# UNITED STATES PATENT AND TRADEMARK OFFICE

APPLICATION NO.	FILING DATE	FIRST NAMED INVENTOR	ATTORNEY DOCKET NO.	CONFIRMATION NO.
10/775,372	02/09/2004	Wayne Hartley	303.002	9922

**Office Action Summary**

### **DETAILED ACTION**

FIG A: US patent 723,033 to Roux, Figure 1. Lead lines and reference numbers added by the examiner.

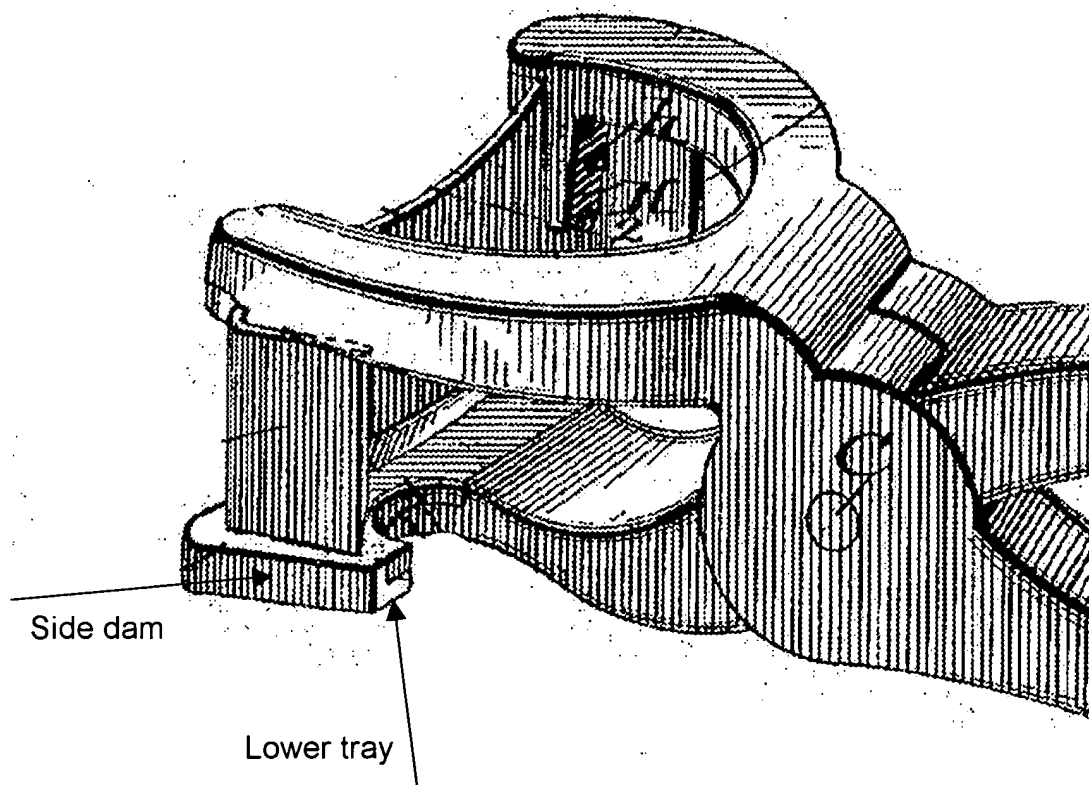
Roux discloses a device capable of clipping nails as claimed, including: a. a lower tray (bottom surface of bed plate D, see the *Figures* section at the end of this Office action); b. a first side dam (side wall of bed plate D, see *Figures* section) extending upwardly from a first side of said lower tray, said first side dam having a generally vertical slot (recessed area D') in an interior thereof; c. a second side dam (side wall of bed plate D on the opposite side) extending upwardly from a second side of said lower tray that is opposite said first side of said lower tray, said second side dam having a generally vertical slot (D') in an interior thereof; d. an upper jaw (including curved arms F) that is displaceable relative to said lower tray; e. a blade (E) that is pivotally mounted to a lower portion of said upper jaw, said blade (E) extending below said upper jaw and into said generally vertical slot (D') in said first side dam and said generally vertical

slot (D') of said second side dam, wherein said blade (E) travels in said generally vertical slot (D') in said first side dam and said generally vertical slot (D') in said second side dam when said upper jaw is displaced relative to said lower tray. The blade (E) can be considered "pivotally mounted" as claimed because it is mounted to an upper jaw that pivots about a pivot point C. In addition, the Roux device anticipates the limitation regarding the blade extending into and traveling in the slot because the blade of the Roux device pierces the cushion G during a cutting operation. It is inherent the blade pierces the cushion during operation because it is disclosed the cushion is made from a soft material and can be removed and replaced. See col. 1, lines 32-38. Finally, while the Roux blade may not be precisely vertical to the lower tray during its full range of motion, it will generally be vertical during a small range of motion, such as to cut a thin work piece, and thus anticipates the claim.
